Historic Landmarks Committee
ZOOM Online Meeting
January 5, 2021 3:00 PM

| Committee Members | Agenda Items |
|----------------------------|---|
| John Mead, Vice-Chair | <ol style="list-style-type: none"> A. HL 4-20: Certificate of Approval for Alteration (Exhibit 1) 806 SE Davis Street B. HL 5-20: Certificate of Approval for Alteration (Exhibit 2) 225 NW Adams Street C. HL 7-20: Certificate of Approval for Alteration (Exhibit 3) 608 NE 3rd Street |

DATE: January 5, 2021
TO: Historic Landmark Committee Members
FROM: Chuck Darnell, Senior Planner
SUBJECT: PUBLIC MEETING: HL 4-20 (Certificate of Approval for Alteration) –
806 SE Davis Street

Figure 2. Rendering

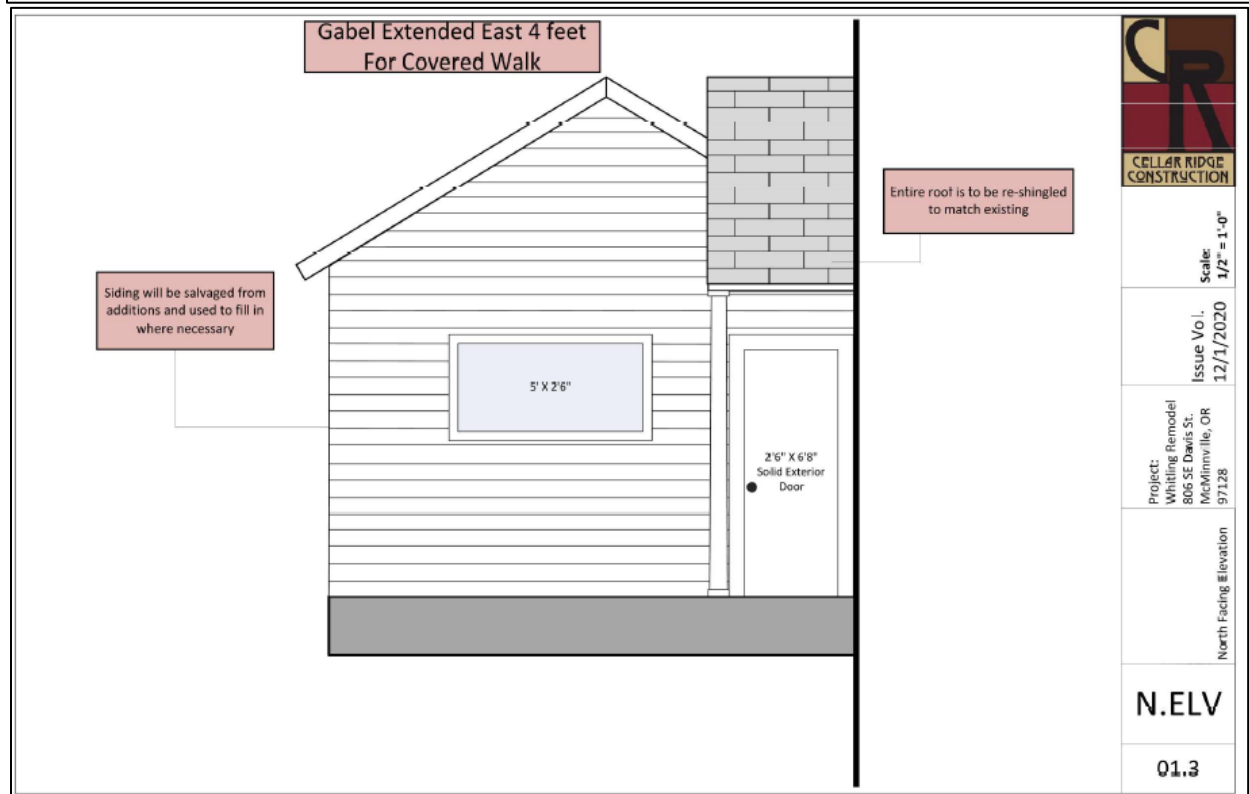
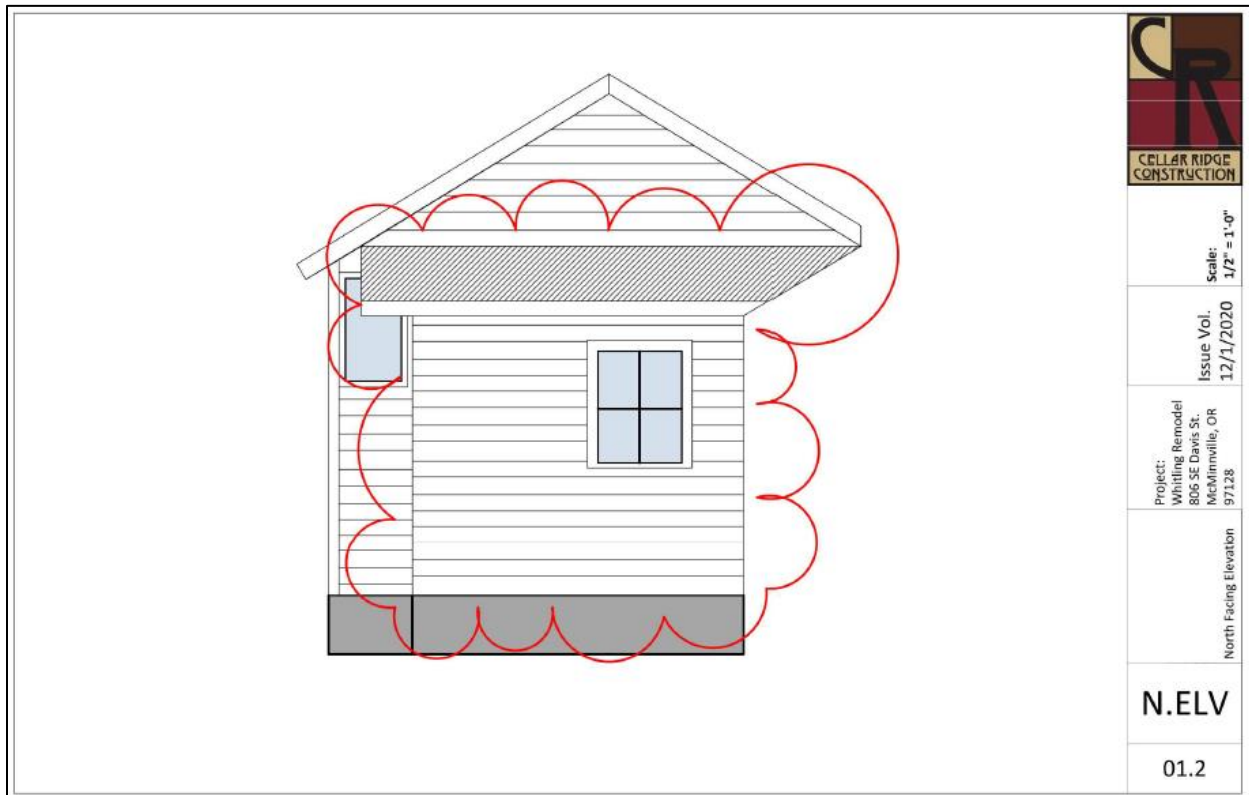
The other alterations, including the removal of the rear additions, extension of the gable roof to create a new rear porch and entrance, and reconfiguration of these exposed rear building facades, are all inter-related. The applicant provided photographic evidence and descriptions of how they believe the existing additions are not original to the structure. Staff also analyzed available Sanborn maps, which reveal that the building footprint was originally more compact and confined to the main home, suggesting that the garage and these additions were added later. Together with the evidence provided by the applicant, staff believes that these porch additions could be removed without resulting in the loss of any significant building feature or space that characterizes the property.

Staff also believes that the alterations to what would then be the exposed and final exterior building facades in this rear area of the building could also be found to be consistent with the applicable historic preservation standards and review criteria. All of these alterations are proposed in areas of the building that are on the rear building facades in locations that are not prominent or highly visible, and are also in an area of the building that is not specifically referenced in the statement of historical significance in the Historic Resources Inventory sheet for the structure. Due to the location of the proposed window, door, and covered patio alterations, and the fact that the alterations would not substantially impact any primary building façade, these proposed alterations generally are not found to detract from the historic character of the historic resource.

FINDING: SATISFIED WITH CONDITIONS #1 AND #2. The City partially concurs with the applicant’s findings. The City agrees that the investment in the structure is a commitment to the continued use and preservation of the historic resource. However, the City finds that the materials proposed to be used in the alterations to the structure would not preserve the historical significance of the structure. Conditions of approval are included to address the door, window, trim, and siding materials, and are described in more detail in findings for other applicable review criteria below. These conditions of approval would still allow the alterations and investment in the historic resource to occur.

Figure 3. Elevations

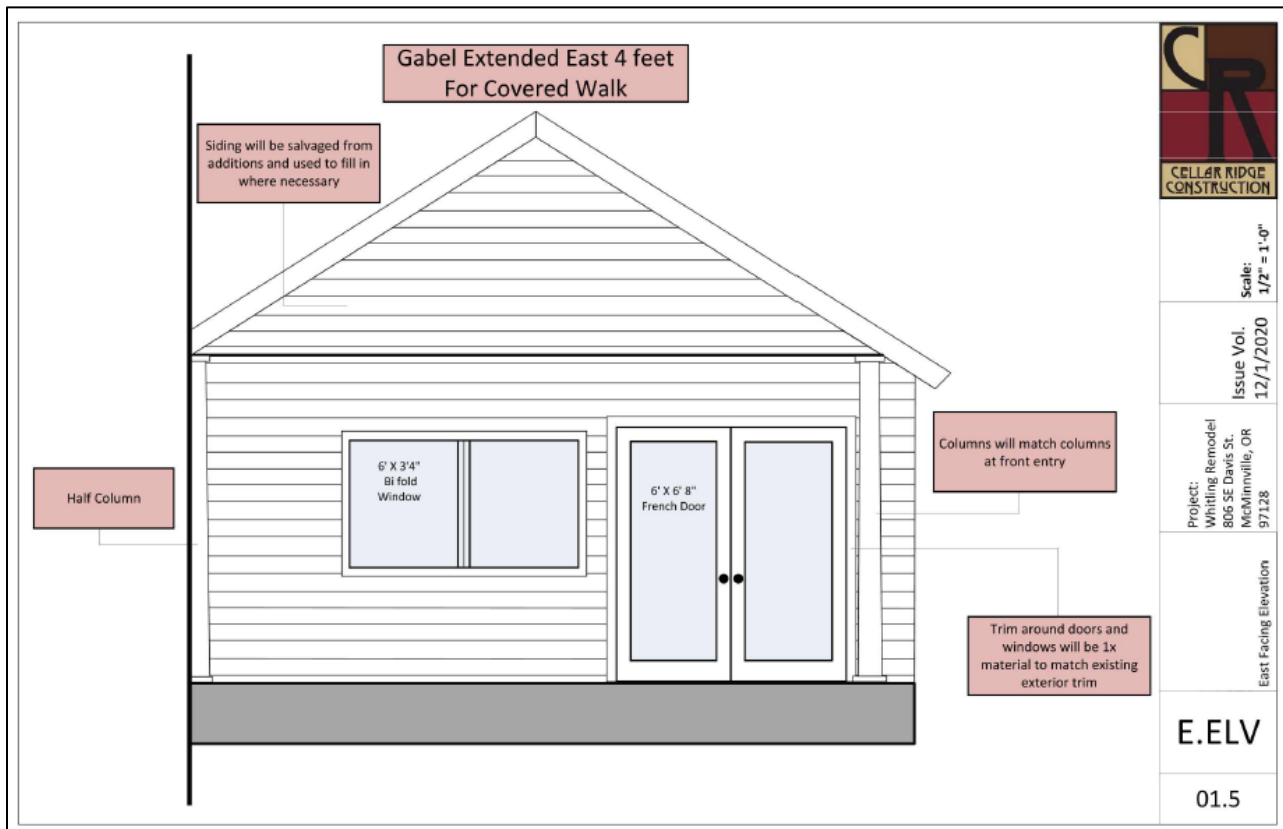
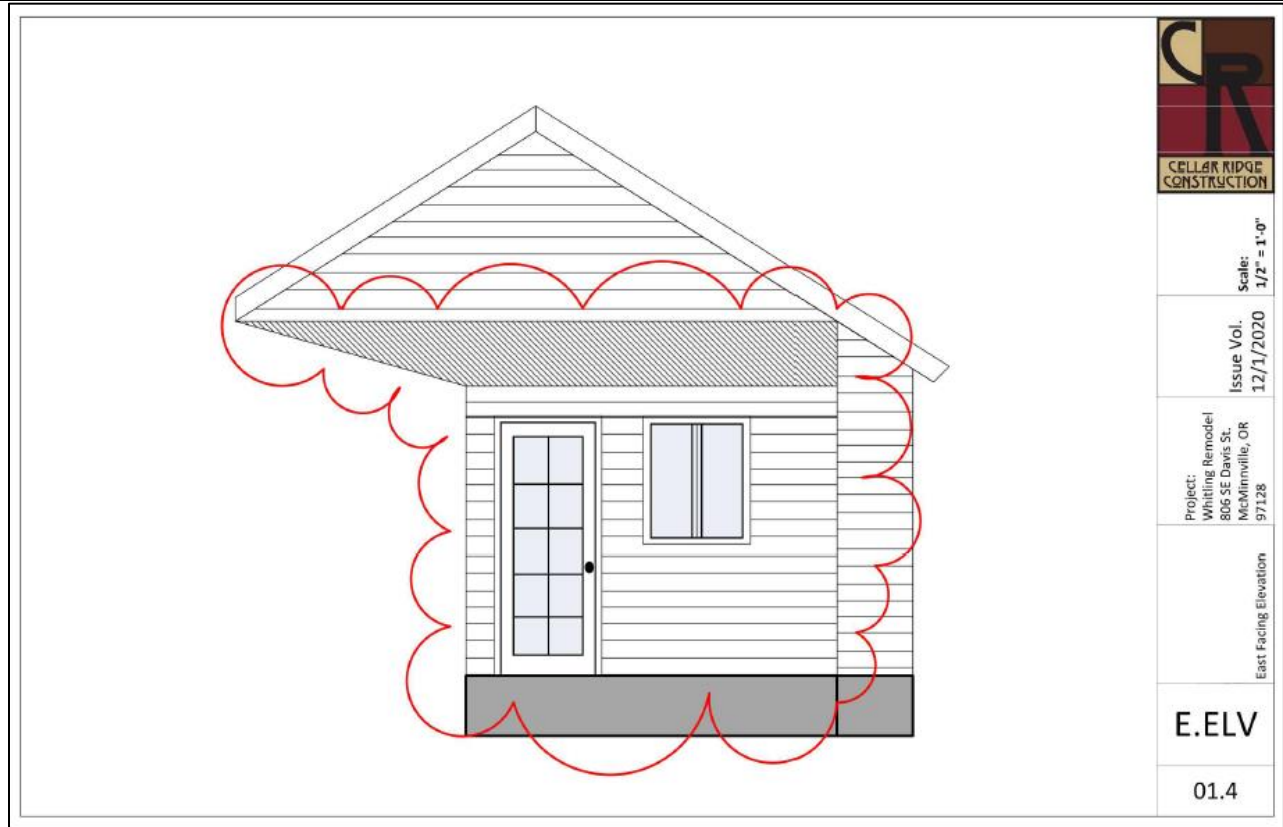
FINDING: SATISFIED WITH CONDITIONS #1, #2, AND #3. The City partially concurs with the applicant’s findings. The City finds that evidence was provided to support the proposed removal of the porch additions, based on evidence that they were added at a later date and not original to the building or property. The porch additions are not associated with the documented historic character of the property and therefore, their removal does not result in the loss of a feature or space that characterizes the property. The footprint of the historic building after their removal will more closely resemble the original footprint and form of the building.

These alterations are proposed in areas of the building that are on the rear building facades in locations that are not prominent or highly visible, and are also in an area of the building that is not specifically referenced in the statement of historical significance in the Historic Resources Inventory sheet for the structure. Due to the location of the proposed window, door, and covered patio alterations, and the fact that the alterations would not substantially impact any primary building façade, the proposed alterations are not found to detract from the historic character of the historic resource. However, the material of the new building components should be consistent with the historic character of the historic resource. The applicant has stated that all other windows on the existing building have been replaced with more modern vinyl windows. However, there are still remaining historic wood materials on the building, including the existing window trim and siding. Wood windows were likely originally on the home and would be more consistent with the remaining historic materials on the building. Therefore, a condition of approval is included to require that the new windows and doors be wood to be consistent with the historic materials that existed on the historic resource and to protect the historic character of the historic resource. The condition also states that the windows and doors be finished with trim that matches the remainder of the house, which may be a 1x4 finger jointed pine as proposed by the applicant. The condition does specify that the more decorative exterior window headers that exist on the front building façade do not need to be included in the window and door trim associated with the new windows and doors, since they are on a rear façade and not including that decorative finish will distinguish the new windows and doors from the old. Another condition of approval is included to require that the siding on all final exterior building facades be a wood, horizontal siding that is consistent with the siding on the remainder of the home.

Figure 2. Elevations

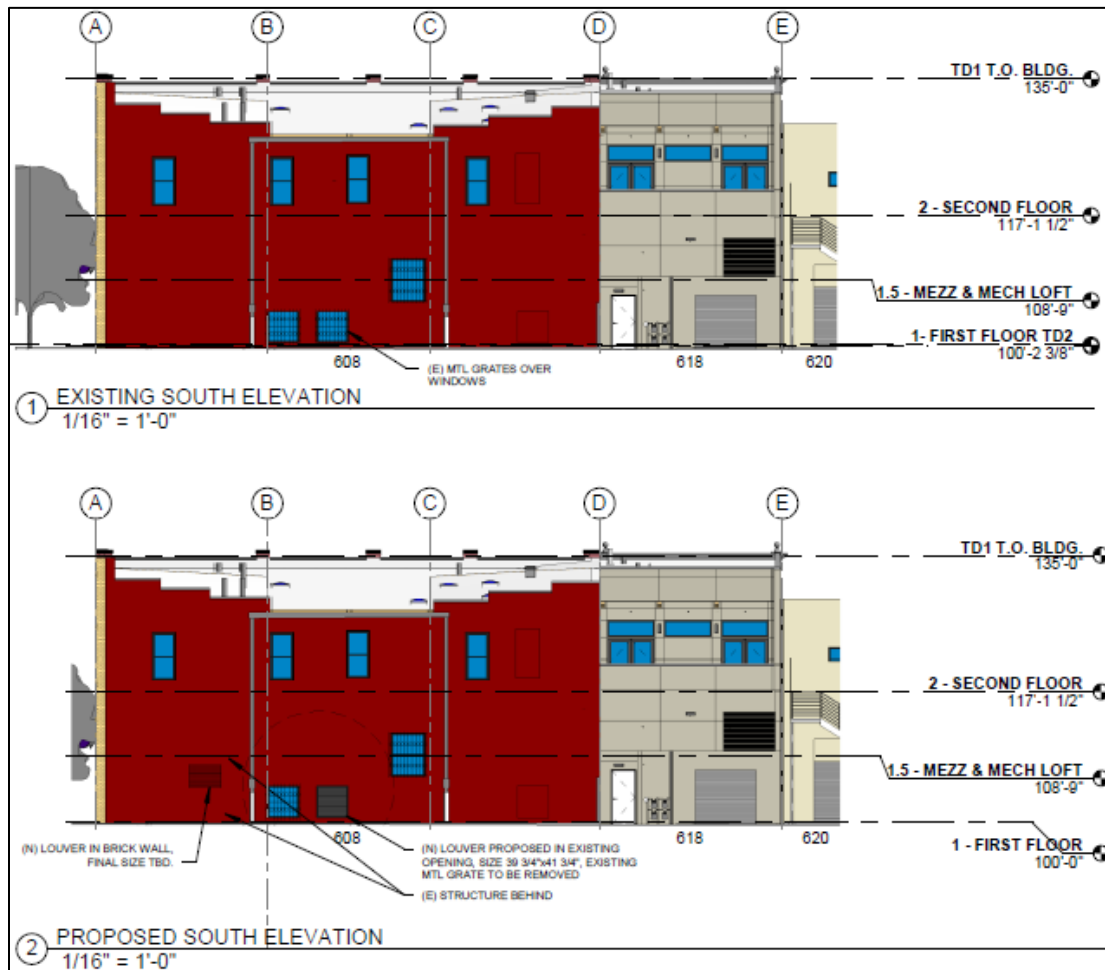
The applicant is also proposing to install the new louvers in a manner that would blend into the existing wall and be as visually compatible with the exterior of the building as possible. The louvers will be painted to match either the color of the surrounding stucco or the window, as applicable. In addition, the proposed construction of the louver in the window opening, as shown in the details provided on Sheet SD-4, would allow for the louver be removed in the future and the window re-established, should the internal use of the building no longer require the ventilation provided by the louver. If the Historic Landmarks Committee finds that the Certificate of Approval application meets the applicable review criteria and should be approved, staff is suggesting that a condition of approval be included to verify that the louvers be installed as shown in the construction details within the application materials.

1. That the louvers shall be finished as proposed in the application narrative and application materials. Specifically, the louver that will be in a new opening in the building façade shall be constructed as identified on Sheet SD-5 and shall be painted to match the color of the surrounding stucco on the building façade. The louver that will be in the existing window opening shall be constructed as identified on Sheet SD-4 and will be painted to match the color of the remaining windows on the south building façade.
